Access Compliance Report Public Rights-of-Way (Curb Ramps)

Main Street: SIENNA_PKWY Cross Street: S_SELLAS_RD Location: SE

ADA ID: RPRK211111133814 Ramp Type: Type 1 - Perpendicular Initial Pass/Fail: Fail Overall Compliance: No Severity Score: 15

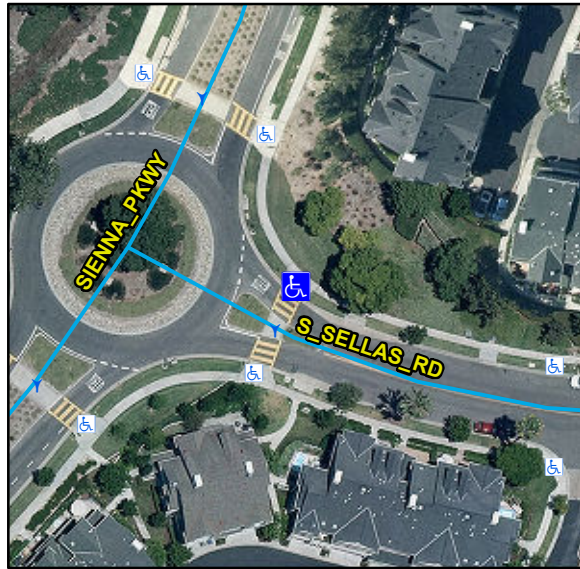
Compliance	Description	Data	Compliance	Description	Data
N/A	Ramp Length (in)	75	N/A	Flare Type LT	
Yes	Ramp Width (in)	48			N/A
No	Ramp Run Slope (%)	11.1	N/A	Flare Slope LT (%)	N/A
Yes	Ramp Cross Slope (%)	1.6	N/A	Flare Traversable LT	N/A
N/A	Landing Present	N/A	N/A	Flare Type RT	
N/A	Landing Length (in)	N/A			N/A
N/A	Landing Width (in)	N/A	N/A	Flare Slope RT (%)	N/A
N/A	Landing Run Slope (%)	N/A	N/A	Flare Traversable RT	N/A
N/A	Landing Cross Slope (%)	N/A	N/A	DWS Provided	N/A
N/A	Landing Movement Obstructed?	N/A	N/A	DWS Contrast	N/A
	Landing Movement Type	N/A	N/A	DWS Length (in)	N/A
N/A	Landing Shared	N/A	N/A	DWS Full Width	N/A
N/A	Clear Space	N/A	N/A	DWS Offset Left (in)	N/A
N/A	Clear Space To Crosswalk (in)	N/A	N/A	DWS Offset Right (in)	N/A
N/A	Marked Crosswalk 1	Yes	N/A	Marked Crosswalk 2	N/A
	Crossing 1 Direction	SW		Crossing 2 Direction	N/A
	Marked Crosswalk 1 Width (in)	144		Marked Crosswalk 2 Width (in)	N/A

Remove & Replace Entire Ramp.
